**November 4, 2025
Addendum #1
FOR IMMEDIATE ATTENTION**

Reference – Invitation for Bid:	IFB #011-0-2026/SB Campus for Student Success Multi-Purpose Room Renovations
For Delivery To:	Newport News Public Schools
Bids Due:	November 14, 2025 at 2:00 PM EST

ADDENDUM NO. 1

Invitation to Bid: IFB #011-0-2026/SB
QE Project Number 42025321 Campus For Student Success Multi-Purpose Room Renovations
Receipt Date/Time: November 14, 2025, at 2:00 PM
Opening Date/Time: November 14, 2025, at 2:00 PM
Subject: Questions and Responses to Bidder questions, Specifications, and Drawings Revisions

FLOOR PLAN - NEW WORK - MECHANICAL

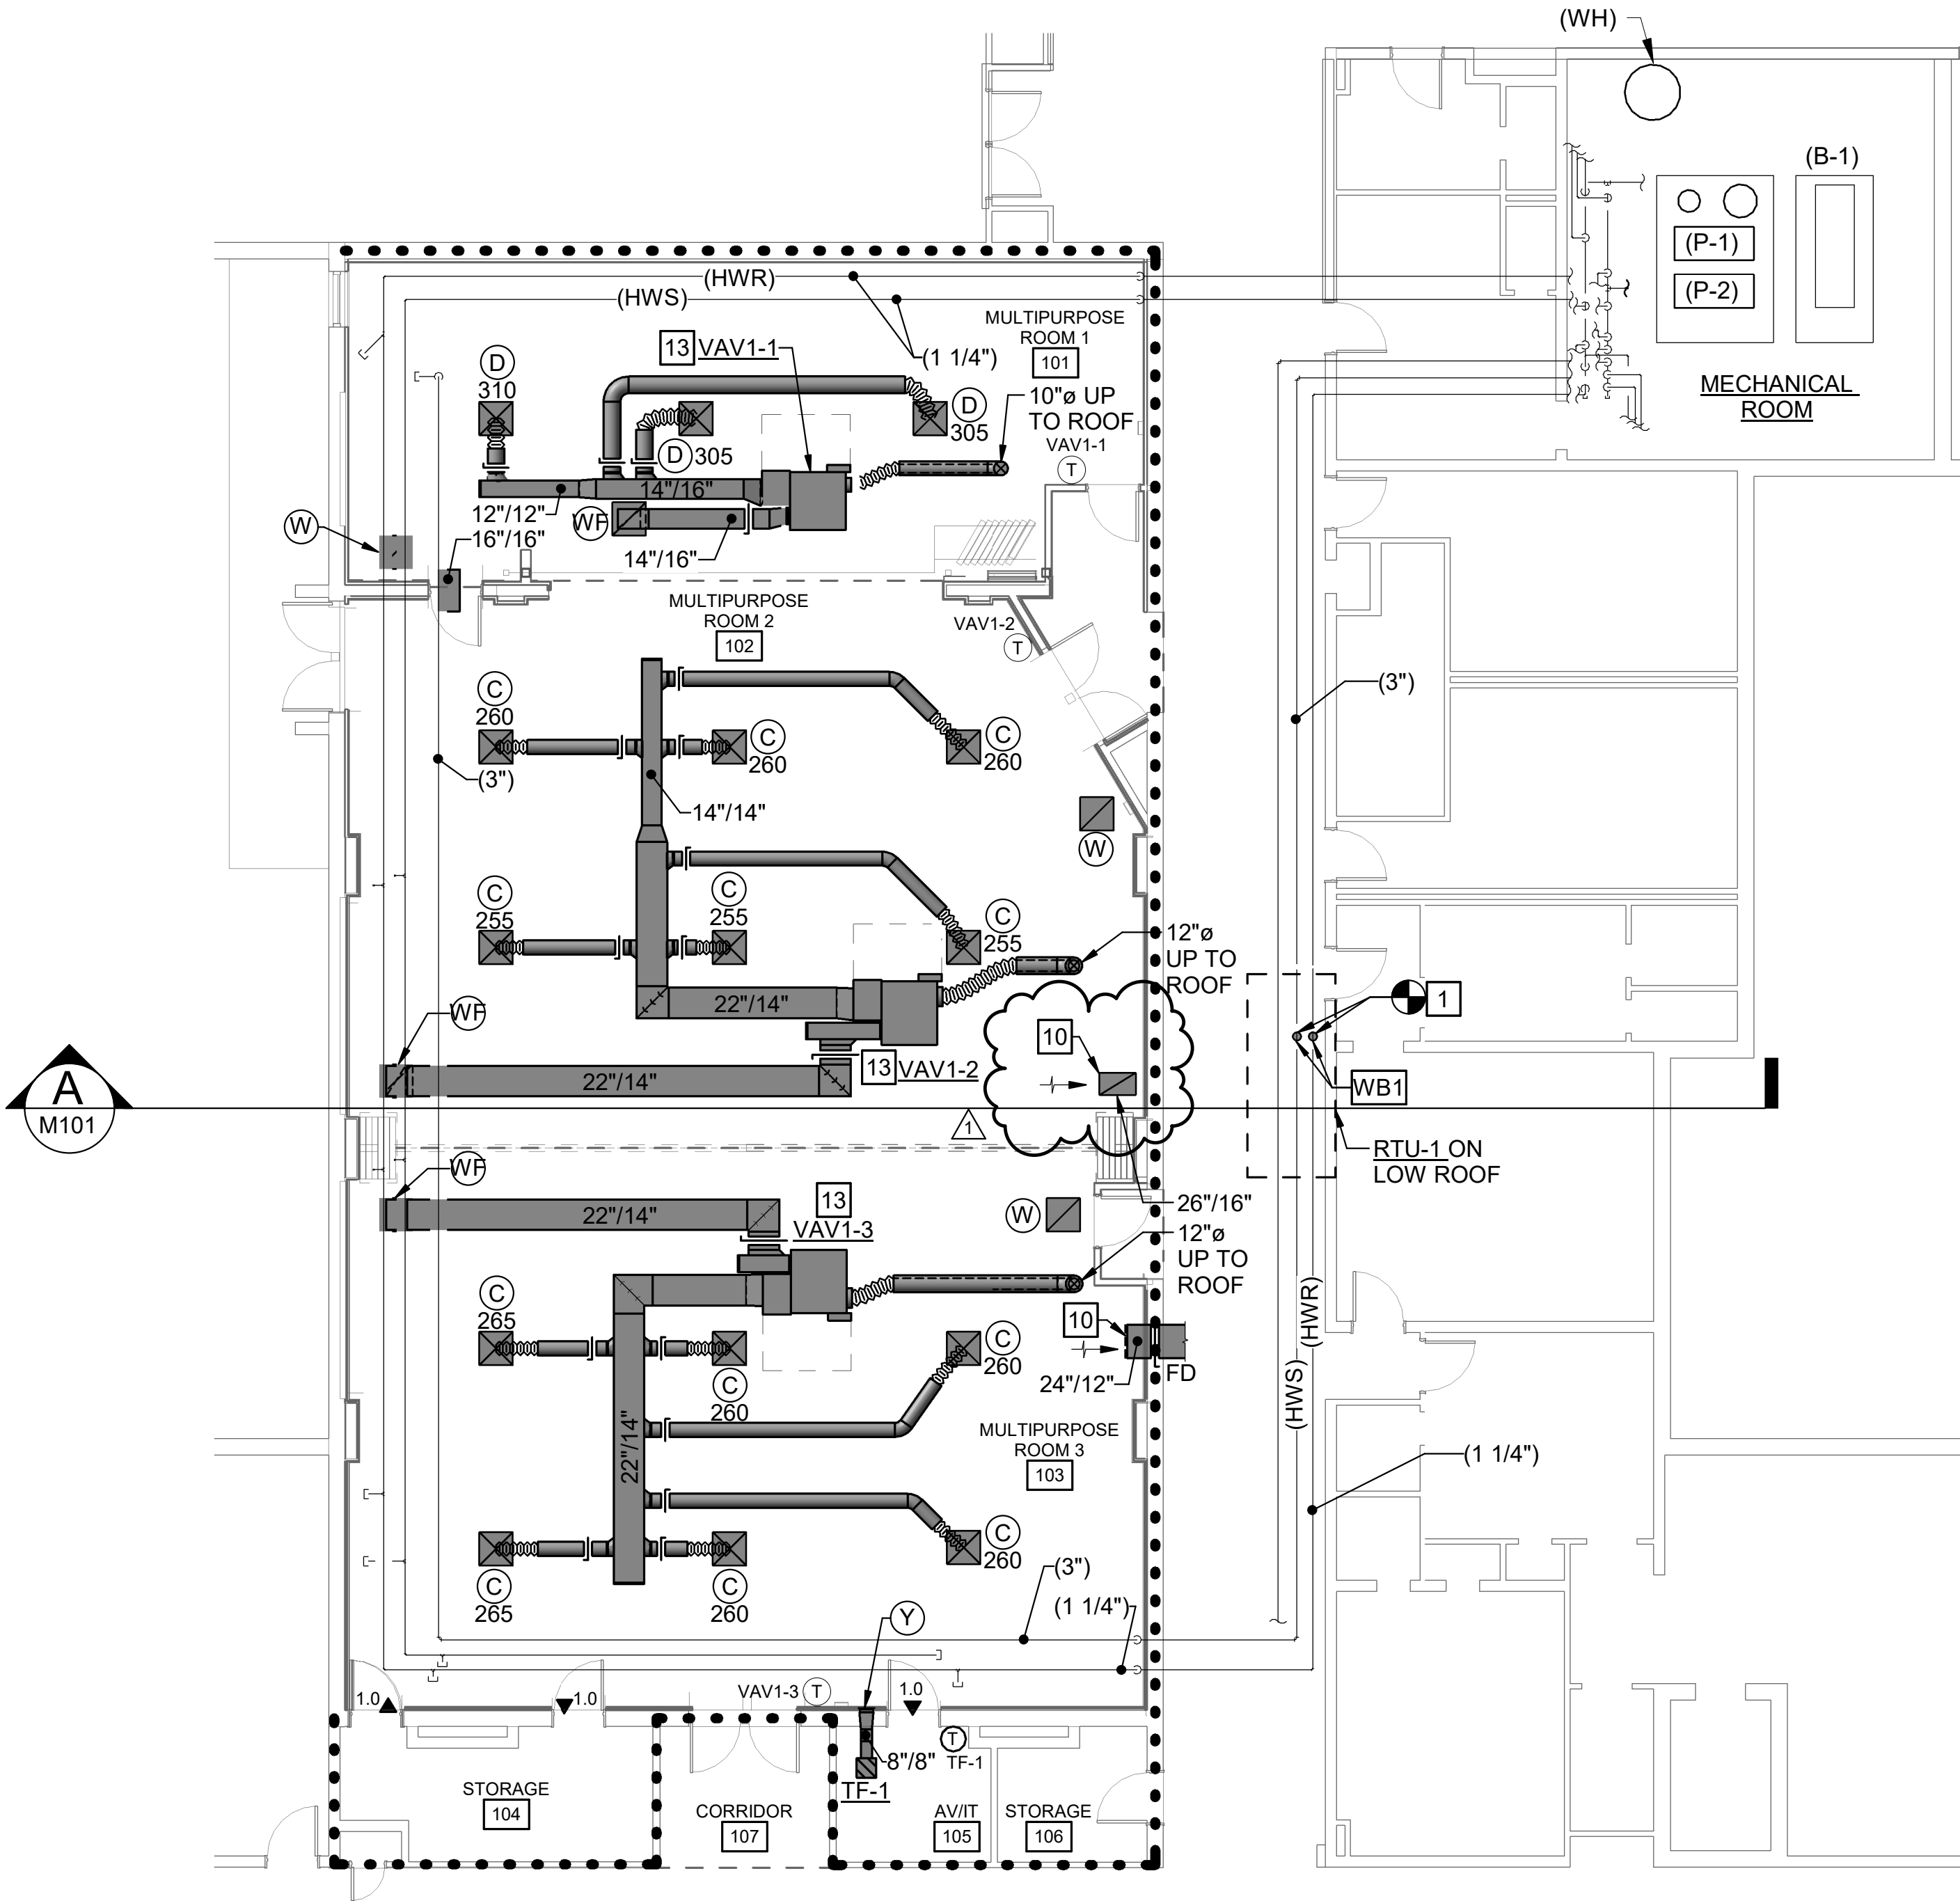
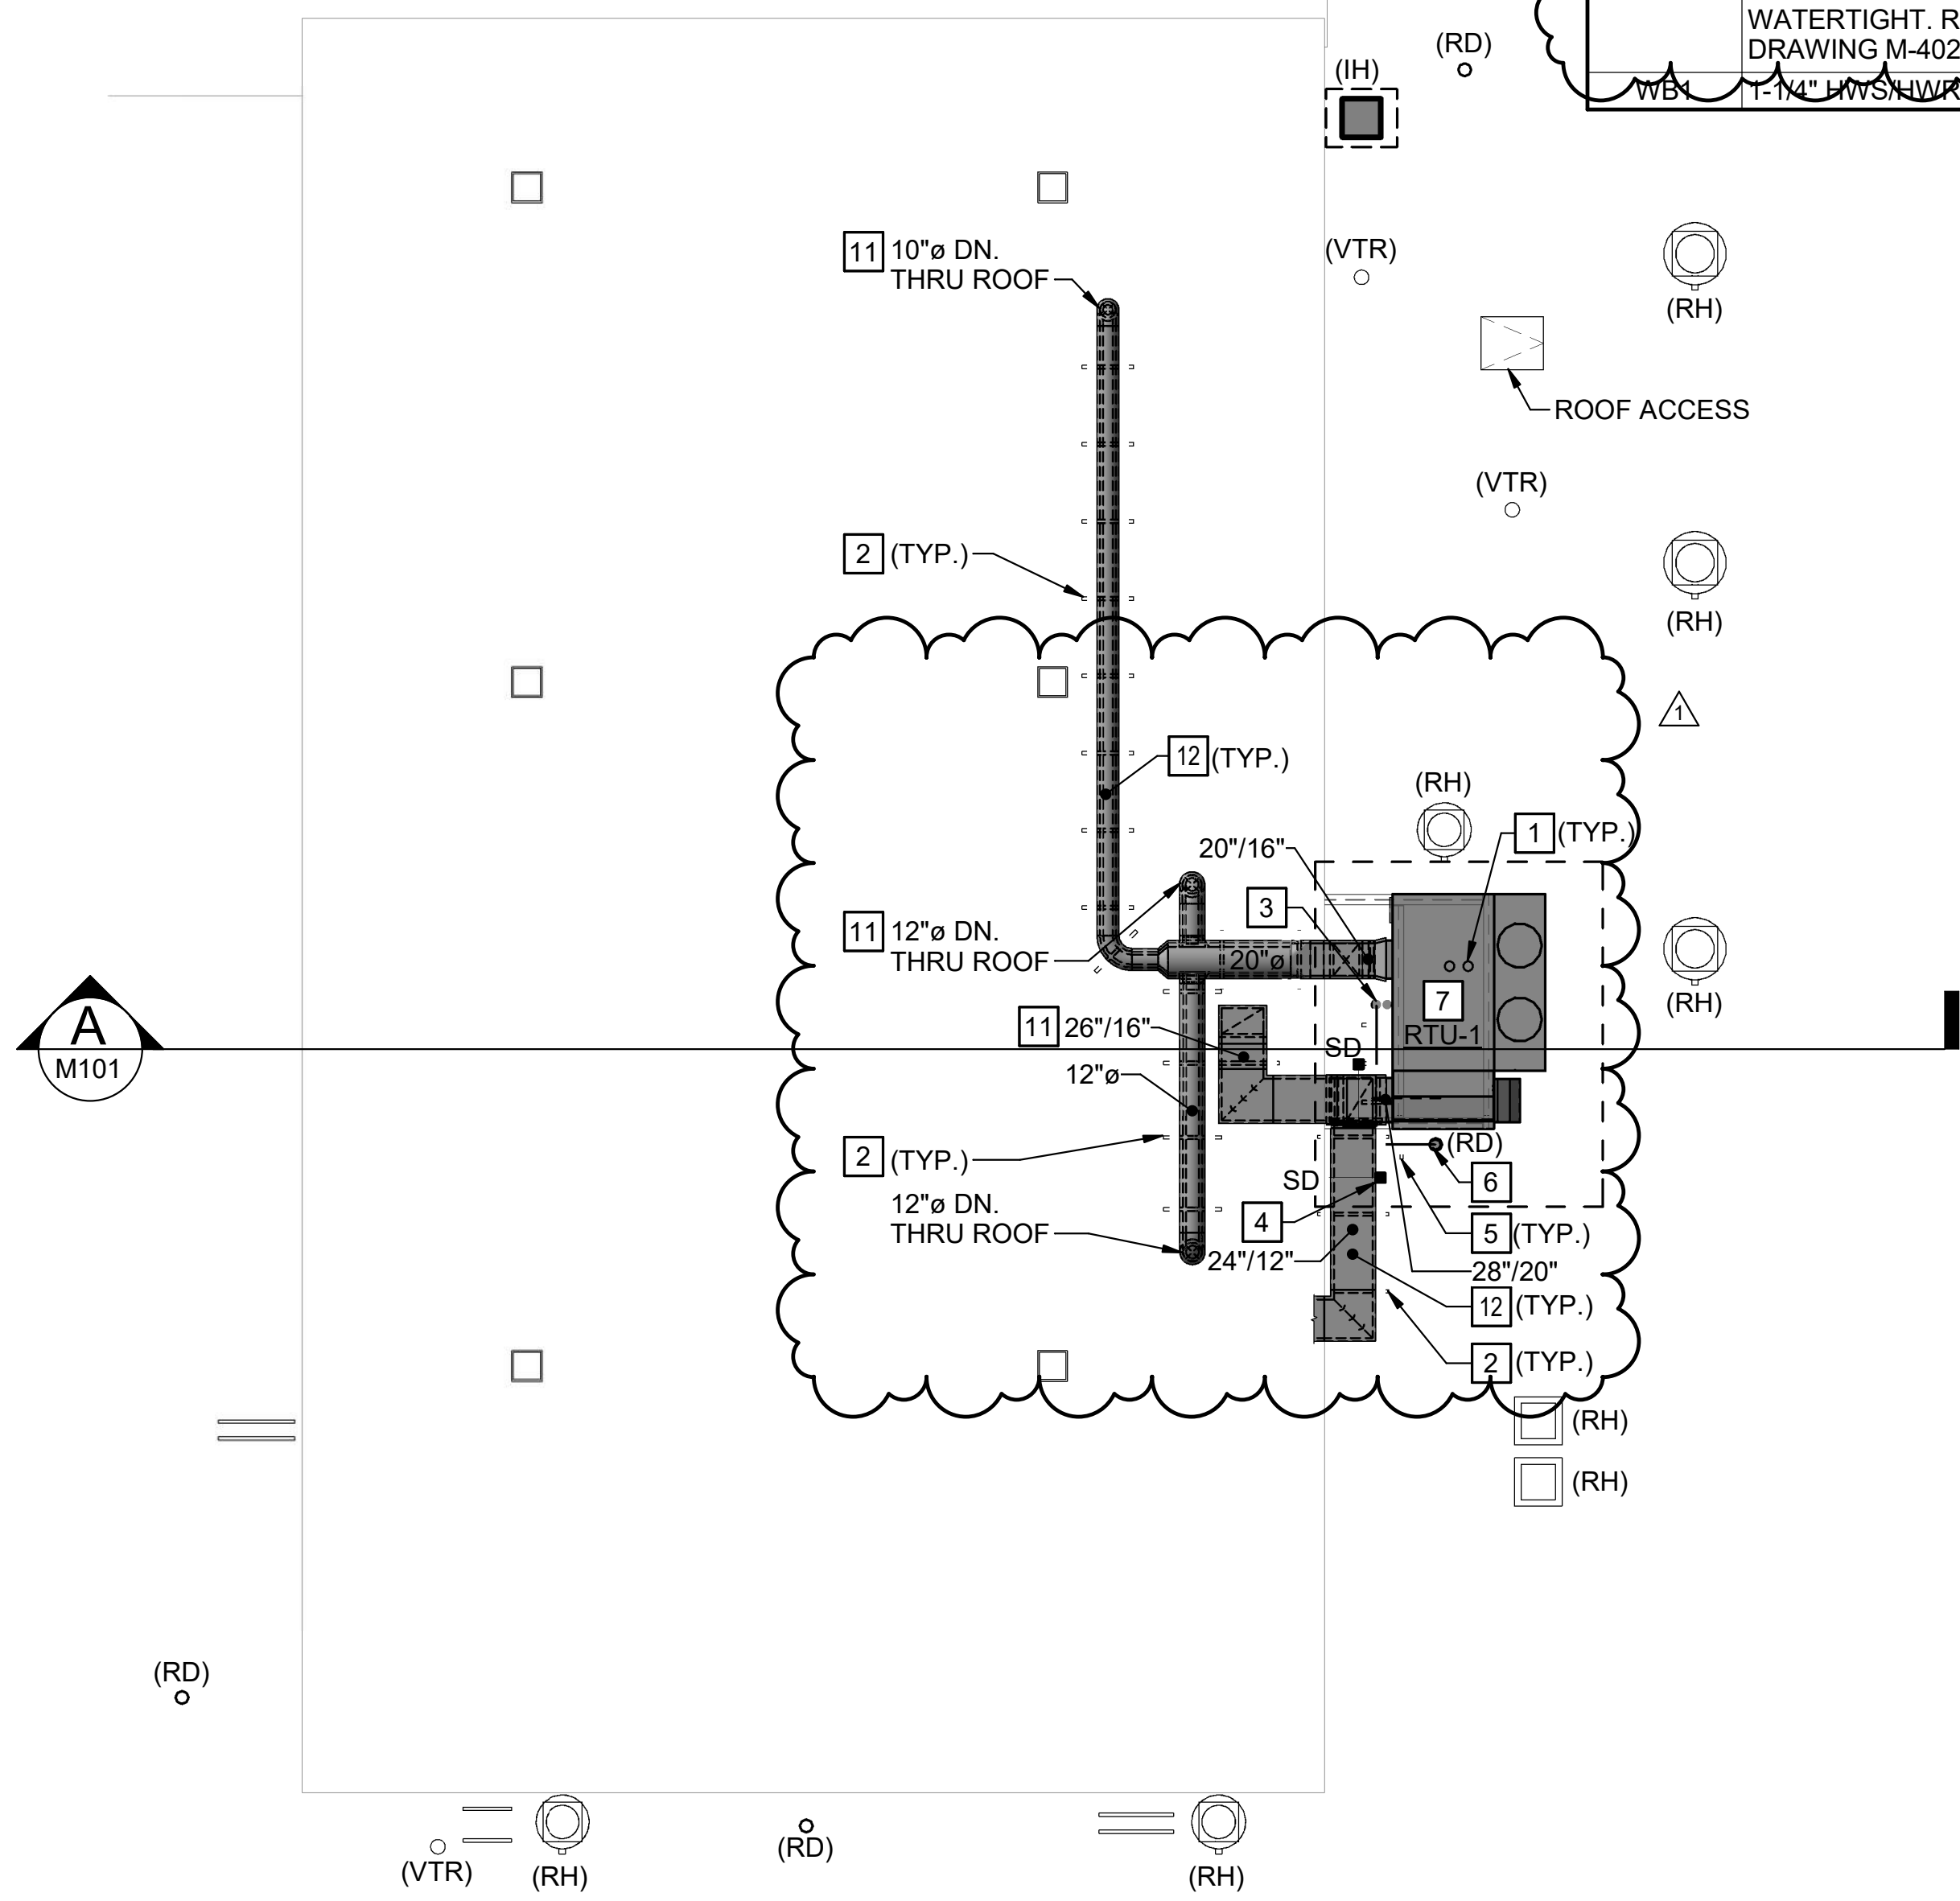
- i) **FLOOR PLANS – NEW WORK – MECHANICAL** – REVISED on drawings. Rooftop unit location shifted plan South along with ductwork modifications on the roof and on the floor plan. Section A revised to accommodate changes to floor plans. Indicated by revision triangle number 1.

- ii) **“NEW WORK NOTES”** Note 7 – REVISED to read “PROVIDE FULL PERIMETER RAIL WITH SPRING ISOLATORS. REFER TO “ROOFTOP UNIT SUPPORT AND VIBRATION ISOLATION DETAIL” ON DRAWING M402. Indicated by revision triangle number 1.

- iii) **“NEW WORK NOTES”** Note 14 – **ADDED:** CONTRACTOR SHALL CUT HOLE THROUGH ROOF FOR HOT WATER PIPING, INSULATE AND PROVIDE HEAT TRACE. CONTRACTOR TO PROVIDE PITCH POCKET, FLASH AND SEAL ALL PENETRATIONS WATERTIGHT. REFER TO HEAT TRACE DETAILS ON DRAWING M-402. Indicated by revision triangle number 1.
